MEETING AGENDA
THURSDAY, FEBRUARY 16, 2017 AT 9:00 A.M.
SUN VALLEY PLANNING AND ZONING COMMISSION
TO BE HELD IN THE COUNCIL CHAMBERS AT SUN VALLEY CITY HALL

- a) **Design Review (DR) 2016-58:** Application for the proposed construction of a new 6,479 sq ft single-family residence with associated site improvements in the Rural Estate and Ranch (RA) Zoning District. Applicant: The Jarvis Group Architects for Bruce Qvale. Location: 212 Sun Peak Drive; White Clouds Corrected Subdivision Lot 19A.
- b) **Design Review (DR) 2016-60:** Application for the proposed construction of a new 3,184 sq ft single-family residence with associated site improvements in the Rural Estate and Ranch (RA) Zoning District. Applicant: Jolyon H. Sawrey for Greg Sanders & Mary Chadez. Location: 324 Juniper Road; Twin Creeks II Subdivision Lot 131A.

**CITY OF SUN VALLEY
PLANNING AND ZONING COMMISSION
AGENDA REPORT**

**FINDINGS OF FACT AND CONCLUSIONS OF LAW
CITY OF SUN VALLEY PLANNING & ZONING COMMISSION
DESIGN REVIEW**

DATE: 01/30/2017
 DESIGN REVIEW
 LANDSCAPE PLAN
L-3

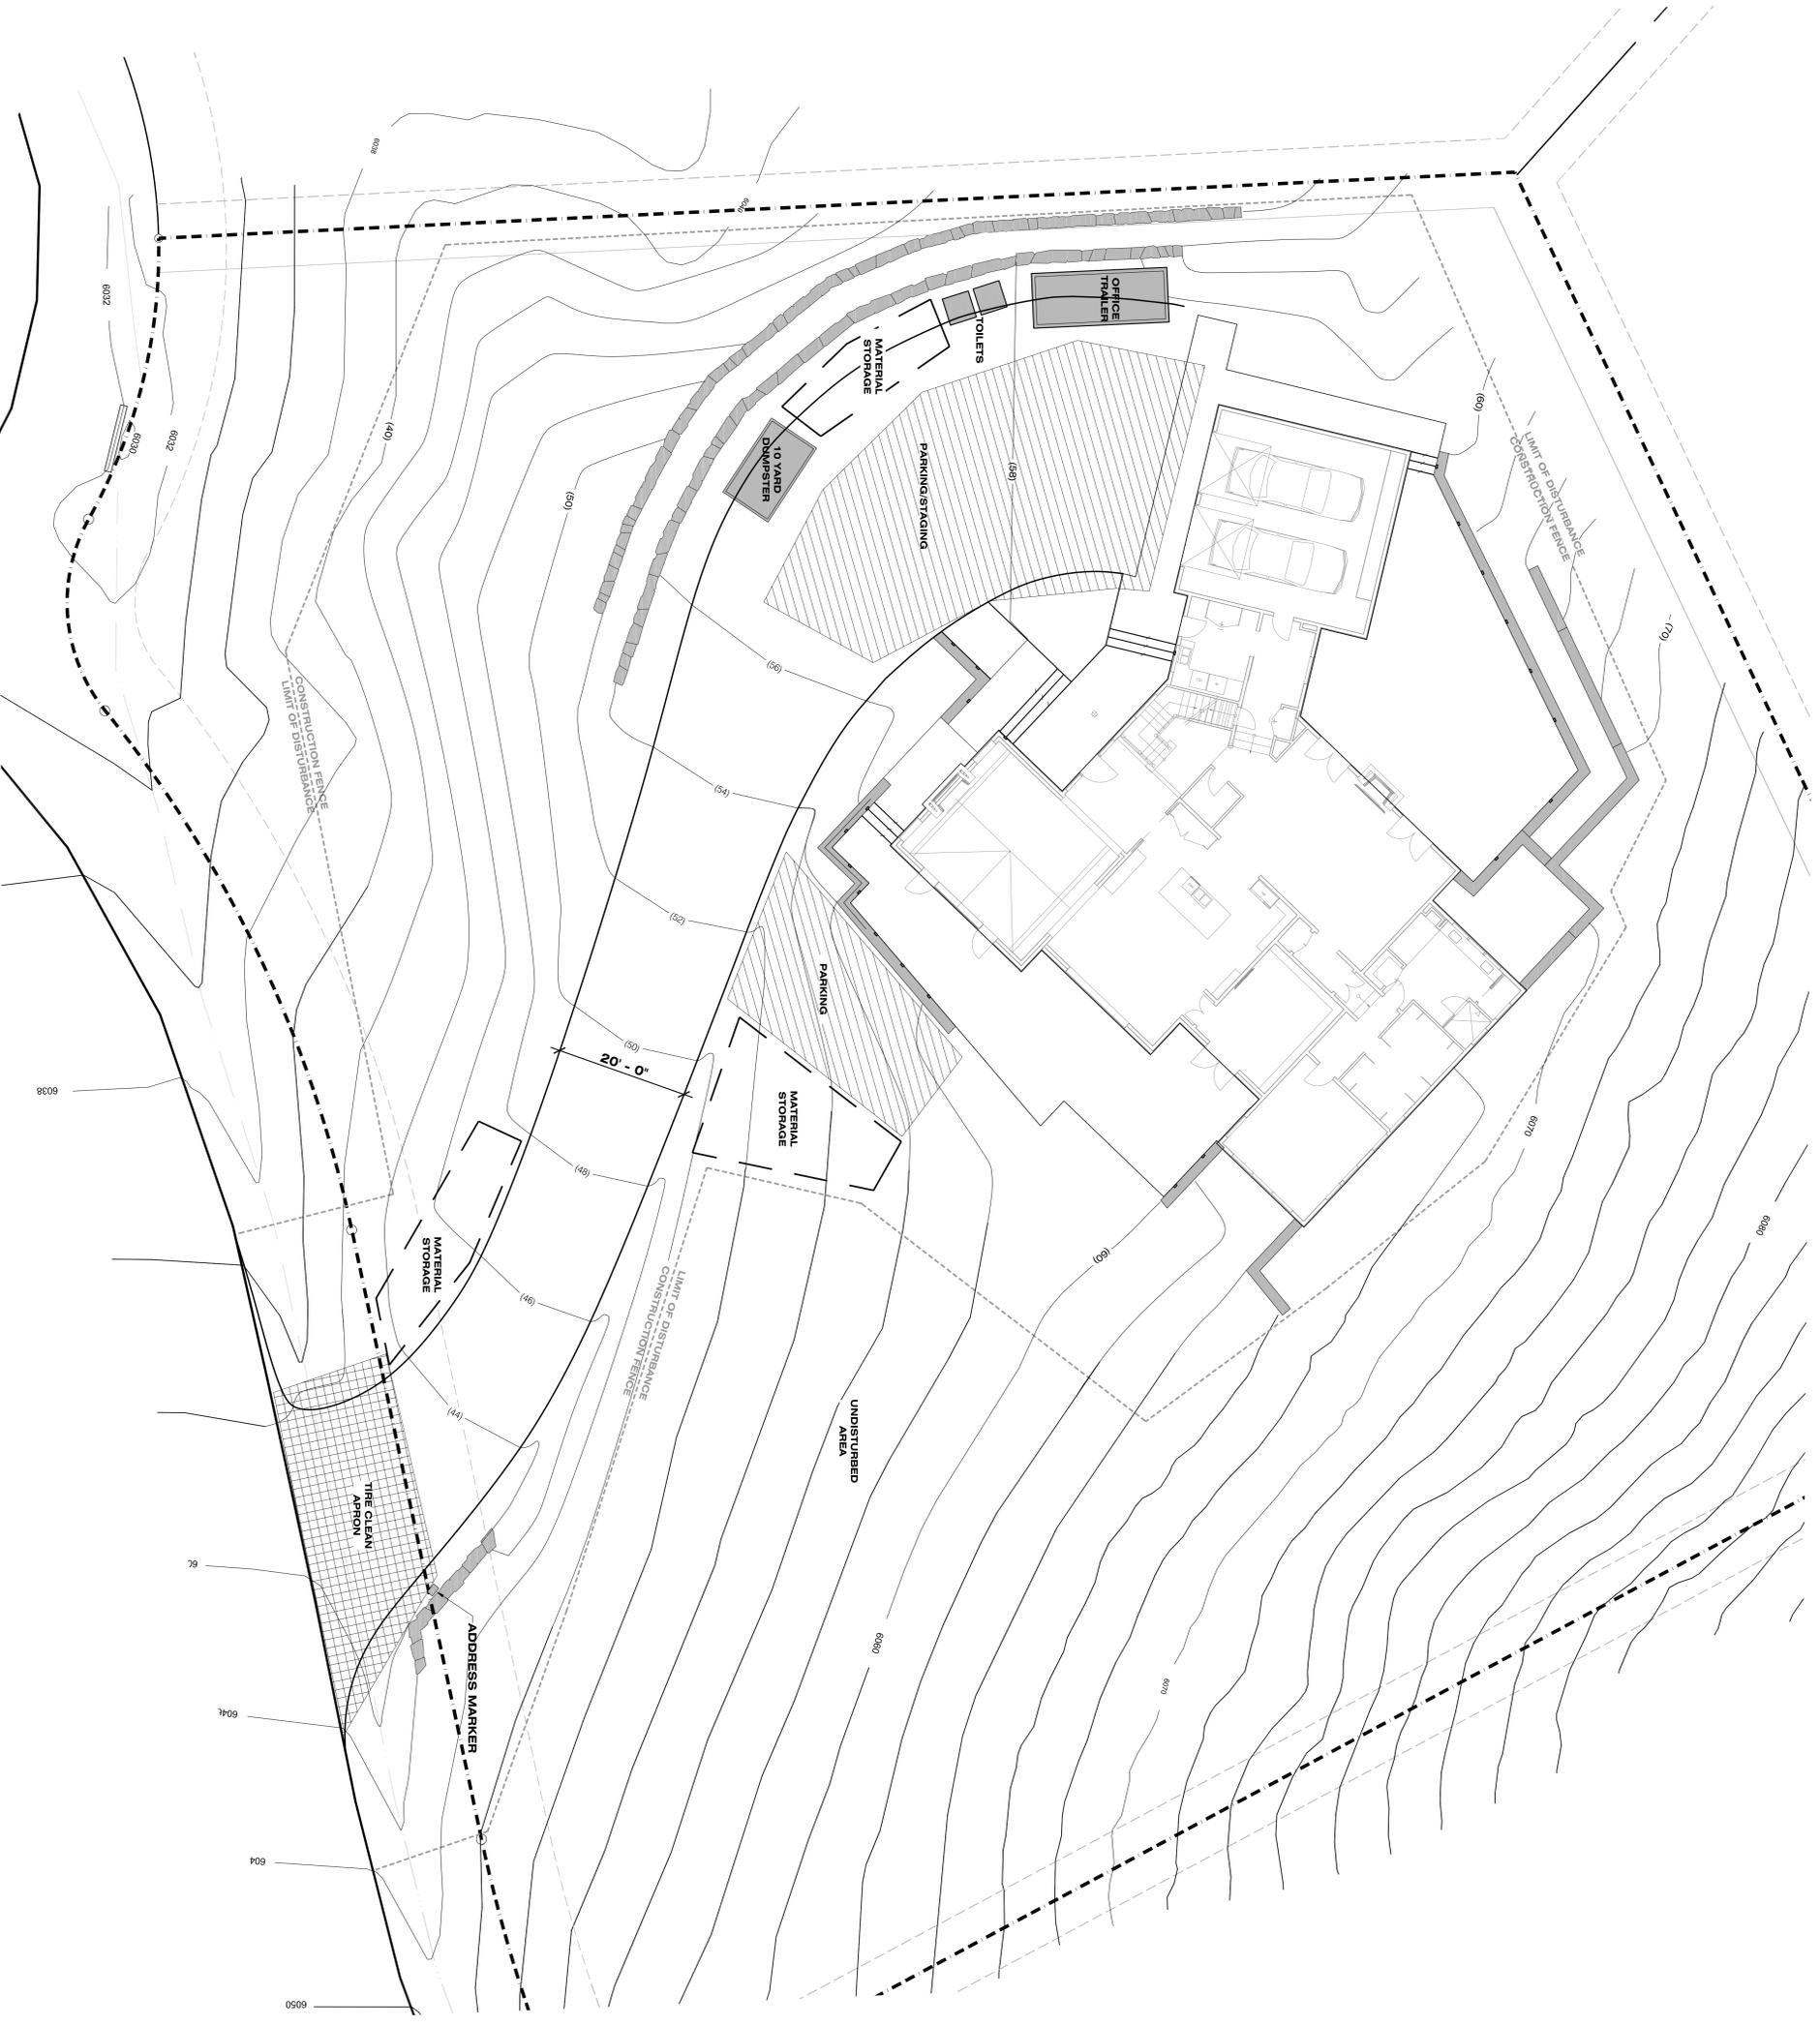
Finally, the “landscaped separation” provided by the applicant (Sheet L-3 and a note from the Landscape Architect) to achieve the relief under § 9-3G-8.D includes only grasses – no shrubs or trees or other substantial vegetation to break up the massing of the walls.

Also during cursory review for completeness, I noticed that the two retaining walls do not appear to comply with 9-3G-8.D of the Municipal Code, which allows for multiple stacked retaining walls provided that there is a 3' landscaped separation between the walls. Though the walls are separated by a five foot (approx.) landing, there's no vegetation depicted on the landscaping plan. The intended vegetation on the landing breaks up the massing of what will appear to be up to 10' of stacked retaining walls. Though this particular item doesn't need to be addressed prior to the hearing, it would be more helpful to the Commission to have this item compliant before their review.

The vegetation that we are proposing between the retaining walls are the Natural Grasses – Fescue Mix – that is being proposed throughout for restoration/revegetation. The natural grasses will grow to approximately 18"-24" high, reducing the overall "visual height"/massing of the retaining by 36"-48". The natural grasses and boulders will blend into the surrounding area better, and look more natural than if additional trees or shrubs are added. In addition, we would like to minimize permanent irrigation in and around the retaining, and the grasses will allow us to turn the irrigation off once it is established.
